# Thomson Avenue Consultation Response Report

Oxfordshire County Council (OCC) proposes to improve the current give-way junction between the A4185 Newbury Road and Thomson Avenue by upgrading it through the provision of new traffic signals. This new design will provide greater capacity to accommodate the predicted future housing and employment growth in the Science Vale area and improve provision for walking and cycling.

Figure 1-Google Map Image of Becquerel Ave

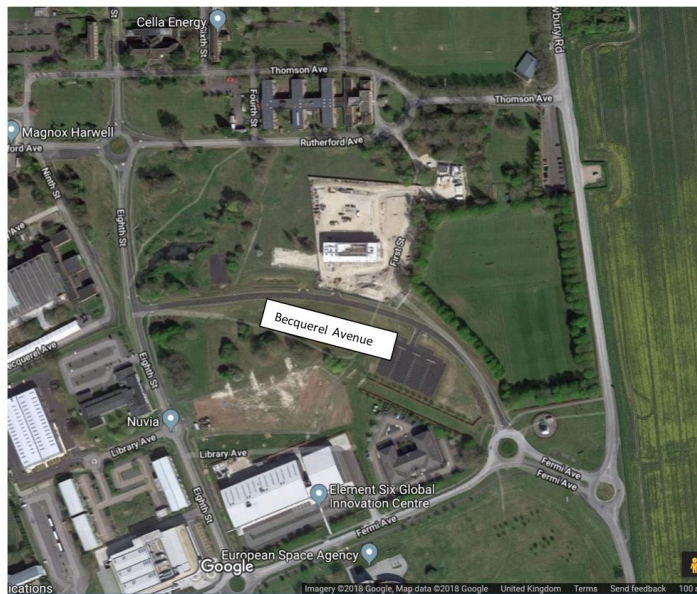
Rather than go for a sub-optimal solution of traffic lights on the A4185, I believe that the new road (not sure if this was considered during options process) within Harwell Campus – Becquerel Avenue - which is easily accessible by the roundabout off Fermi Avenue and links to Eighth Street to should be used as the main route into the expanding Campus – see map below. This would (compared with the current proposal):

- Prevent the need for a new set of traffic lights on the A4185 thereby improving traffic flow on this busy A road
- Improve road safety for all users
- No requirement to move bus stop
- Provide one main entrance to the Campus via Fermi Avenue with good road access to all areas within the expanding Campus
- Separate Campus traffic from A4185
- Save Money - which could be used to repair the A4185
